ADDENDUM 2
RE: Project Bidding Documents for:

WILLIAM COLLIER ELEMENTARY SCHOOL
SHADE STRUCTURE ADDITION &
PLAYGROUND IMPROVEMENTS
LAKE ELSINORE UNIFIED SCHOOL DISTRICT

DSA Appl. No. 04-125584
DSA File No. 33-15

tBP Project No. 24006.00

SITE DEMOLITION PLAN

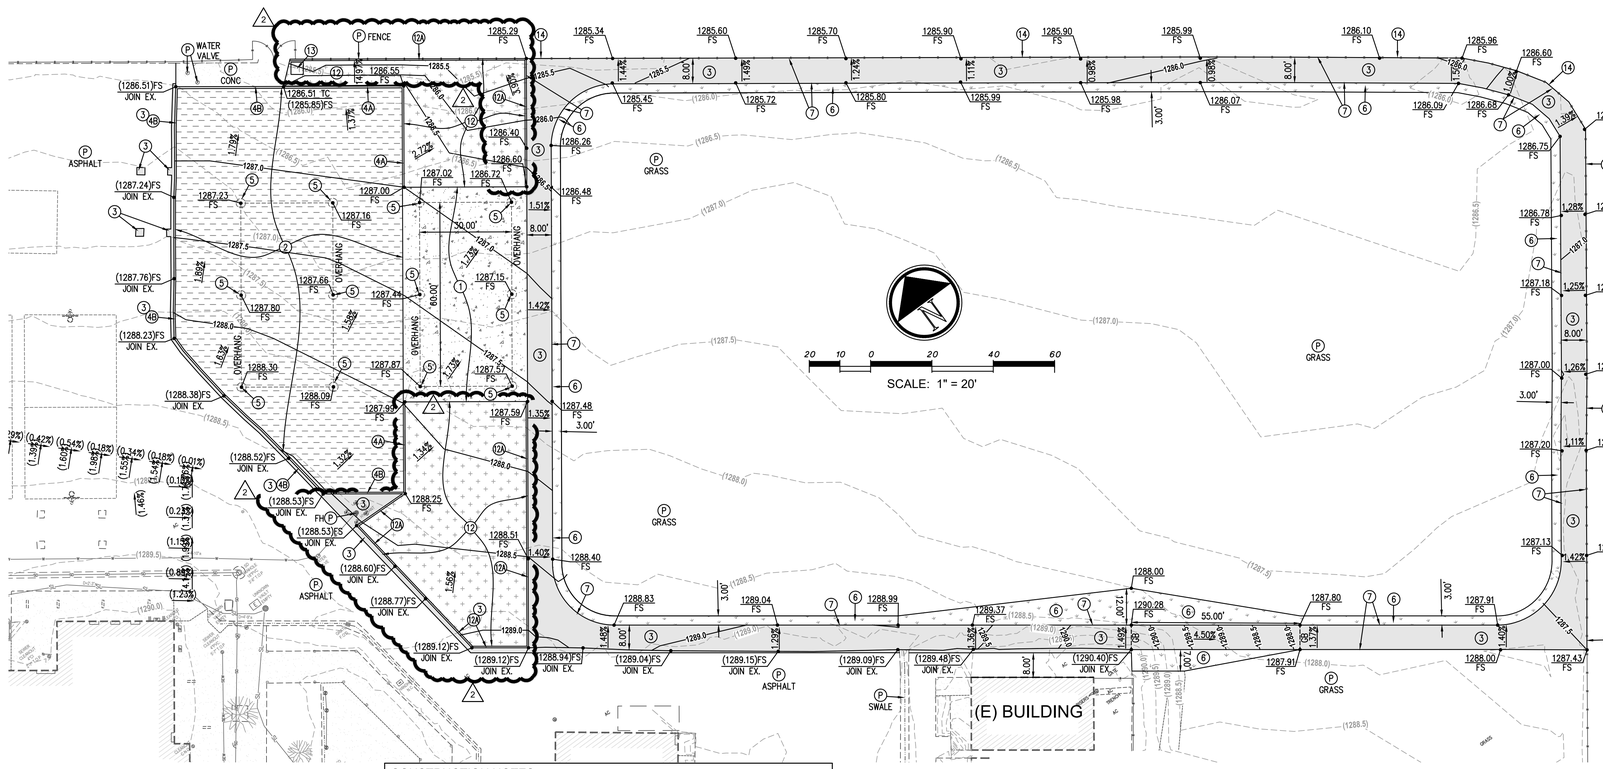
2. Sheet C1.00 SITE DEMOLITION PLAN (Refer to revised ***C1.00***)
    a. Revised plan to clarify additional asphalt removal for new concrete curb.

GRADING PLAN

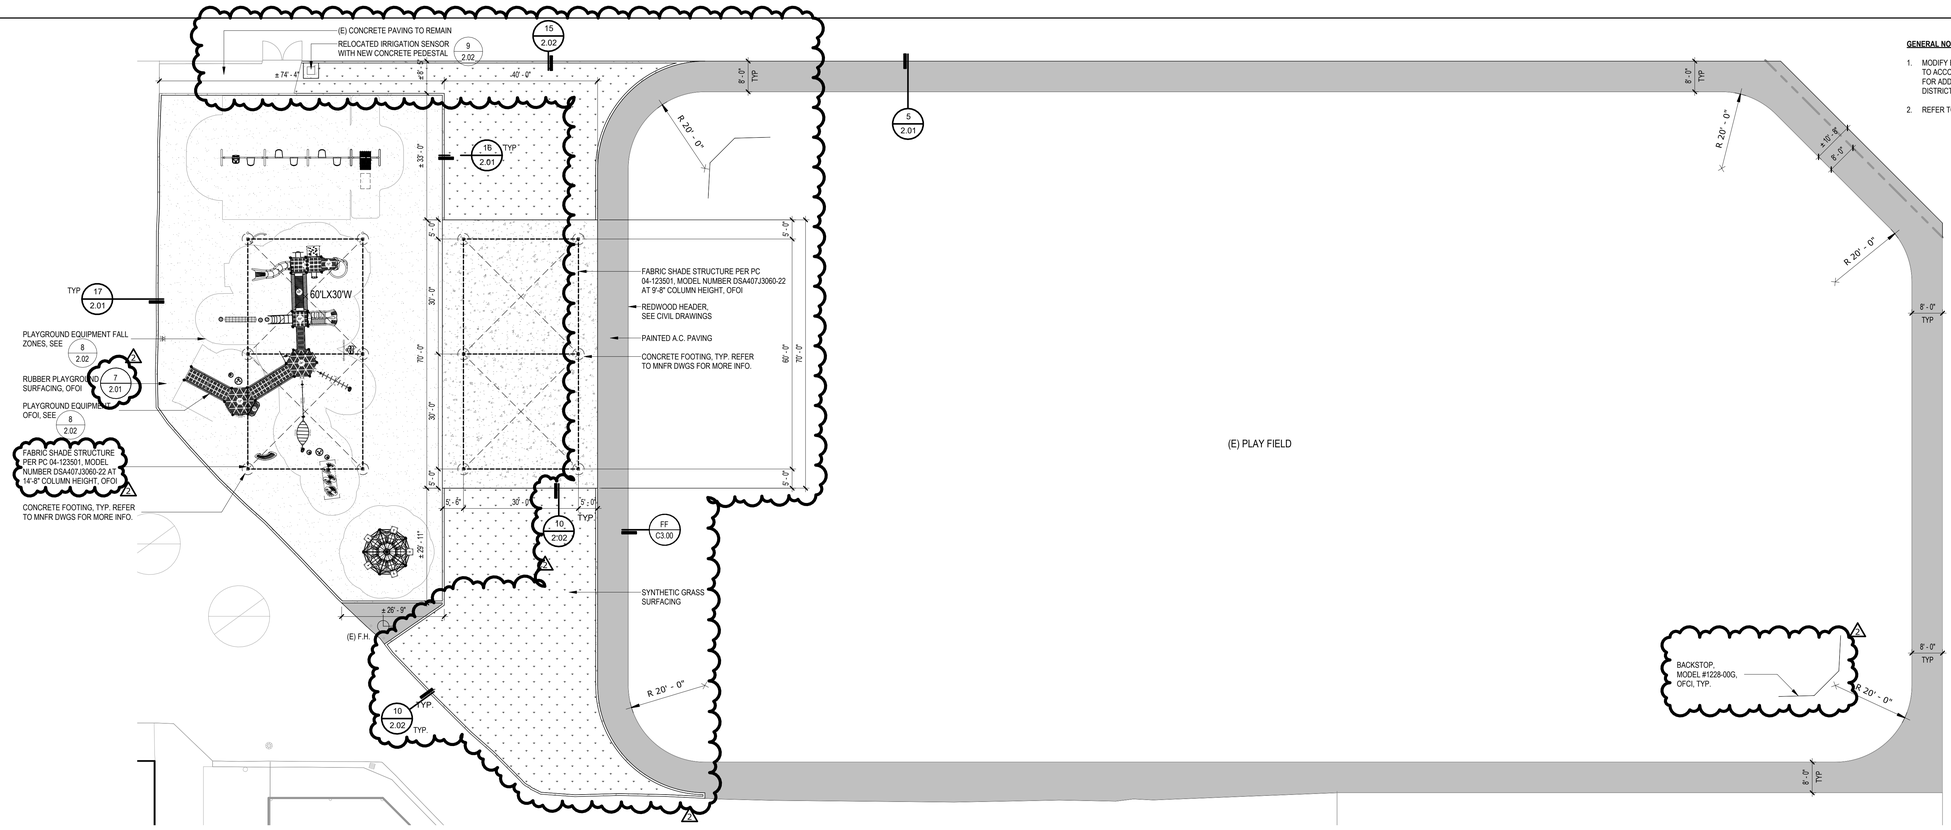
3. Sheet C2.00 GRADING PLAN (Refer to revised ***C2.00***)
    b. Revised plan to clarify locations for keynotes 4A and 4B.
    c. Revised plan to provide concrete curbs at Artificial Turf boundary.

ENLARGED SITE PLAN - PLAYGROUND AND TRACK

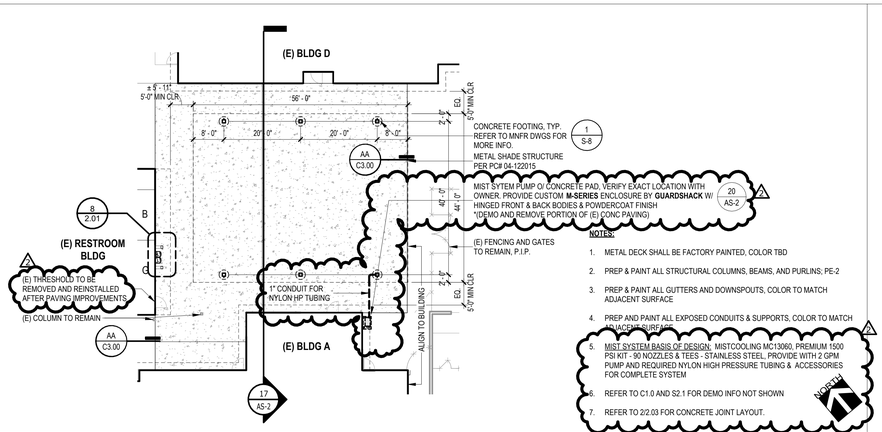
5. Sheet AS-2 ENLARGED SITE PLANS (Refer to revised ***AS-2***)
    a. Revised 10/AS-2 to clarify:
        - Concrete joint layout
        - Detail reference to 7/2.01 for Rubber Playground Surfacing pattern
        - Detail reference to added detail 9/2.02 for concrete pad at relocated irrigation controller
        - Fabric shade column height
        - Redwood header locations
        - Chain-link backstop scope
        - Detail references to added details 10 & 15/2.02 for Artificial Turf edge conditions at concrete paving, A.C. paving, and existing chain-link fence.
    b. Revised 12/AS-2 to clarify:
        - Concrete joint layout
        - Removal and re-installation of (1) existing threshold
        - Mist system
        - Reference to C1.0 and S2.1 for trellis demolition

Enlarged Plan 10 on Sheet AS-2 indicate playground equipment area designated as OFOI, along with OFOI fabric shade structure.

ENLARGED SITE RCP - LUNCH SHELTER

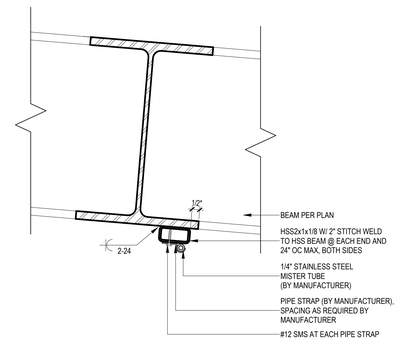
c. Revised 14/AS-2 to clarify:
    - Detail reference to 14/S-10 for light fixture installation
    - Reference to S2.2 for trellis demolition
    - Mist system
d. Revised 17/AS-2 to clarify mist system
e. Added detail 15/AS-2 for Mister Connection
f. Added detail 20/AS-2 for Mist Pump Layout

DRINKING FOUNTAIN ELEVATION — SCALE: 3/4" = 1'-0" — 4

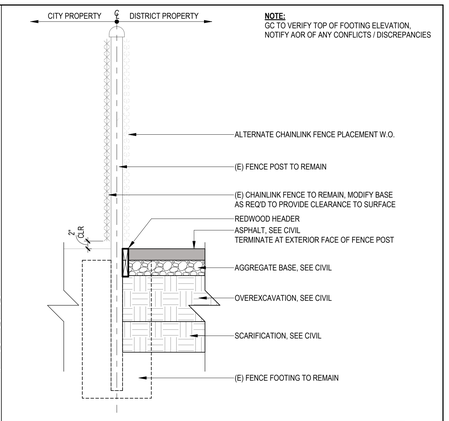
7. Sheet 2.01 SITE AND MISC. EXTERIOR DETAILS (Refer to revised ***2.01***)
    a. Revised 4 & 9/2.01 to clarify accessible drinking fountain height to be installed at +2'-10" AFF (Bubbler Height).
    b. Revised 8/2.01 to clarify 15" MIN from accessible drinking fountain centerline to face of adjacent wing wall.
    c. Revised 12/2.01 to clarify curb extension attachment to existing curb.
    d. Revised 16 & 17/2.01 to clarify:
        - Surfaces adjacent to curb.
        - Subgrade compaction to 90%
    e. Revised 19 & 20/2.01 to clarify portion of existing GLB to remain.

CONCRETE PAD
SCALE: 1 1/2" = 1'-0"
9

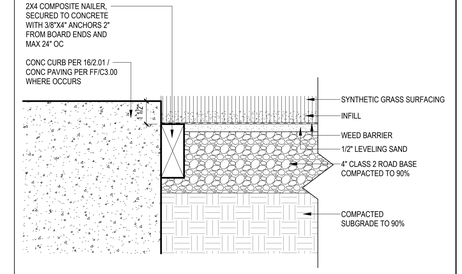
8. Sheet 2.02 PLAYGROUND DETAILS (Refer to revised ***2.02***)
    a. Added detail 9/2.02 for concrete pad at relocated irrigation controller
    b. Added detail 10/2.02 for Artificial Turf at concrete curb / paving
    c. Added detail 15/2.02 for Artificial Turf at existing chain-link fence

WORKSTATION / COUNTERTOP SECTION SCALE: 1 1/2" = 1'-0" 16

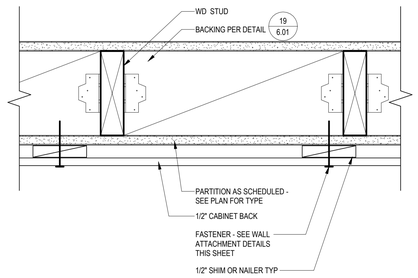
b. Revised 5/6.01 to clarify:
    - Detail references to 12/S1.2 for ceiling framing end connection, typ.
    - Keynote 1 description
c. Revised 16/6.01 to clarify:
    - Plywood substrate thickness
    - Overall counter thickness
    - Support L-Brackets to be painted

(E) RESTROOM WALL - TILE ONE SIDE 1

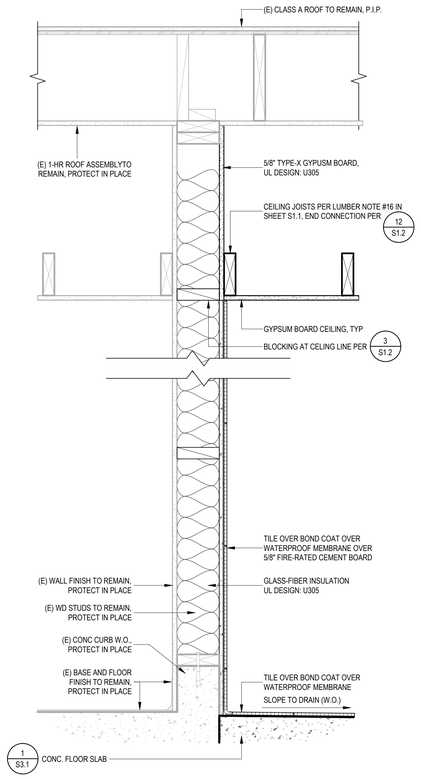
10. Sheet 6.02 WALL TYPES AND MISC. INTERIOR DETAILS (Refer to added ***6.02***)
    a. Added detail 1/6.02 for wall type G-6 (E) RESTROOM WALL - TILE ONE SIDE
    b. Added detail 2/6.02 wall type H-6 (E) RESTROOM WALL - TILE ONE SIDE - 1-HR

2 SHADE STRUCTURE POWER PLAN
SCALE: 1/8" = 1'-0"

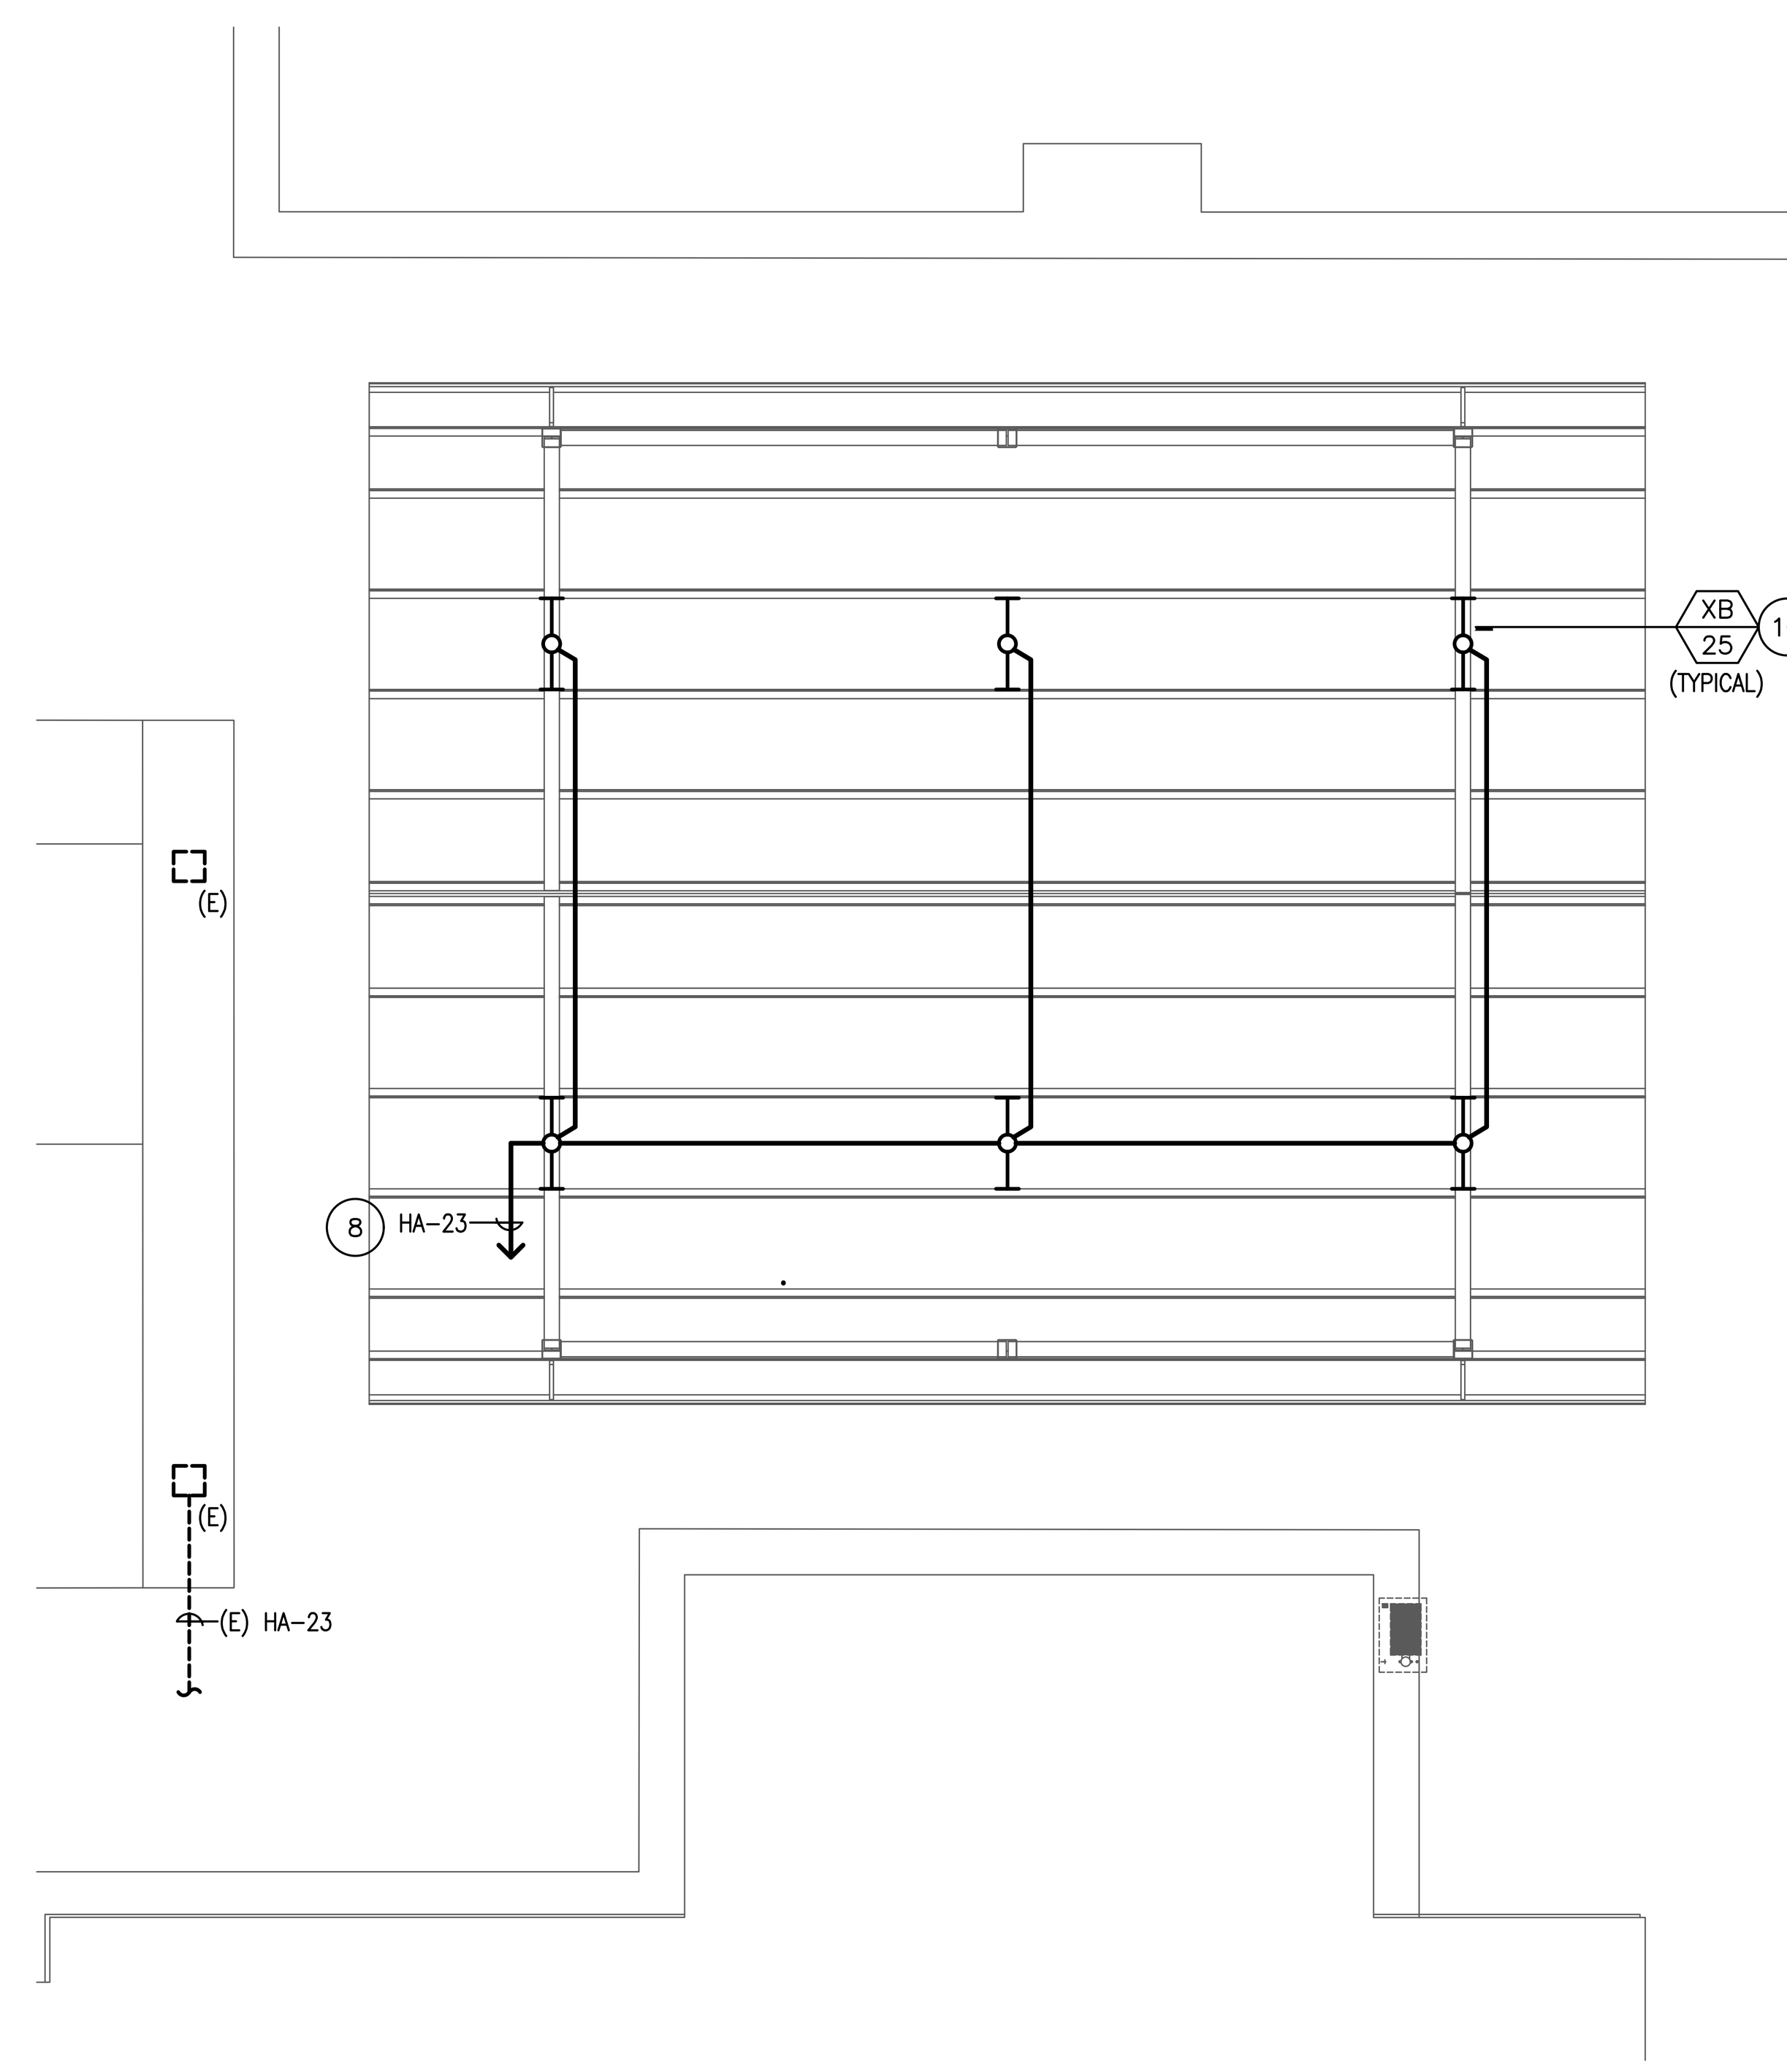
14. Sheet E2-1 FIRE ALARM, LIGHTING AND POWER FLOOR PLANS (Refer to revised ***E2-1***)
    a. Revised 2/E2-1 to provide receptacle for Mist System Pump.
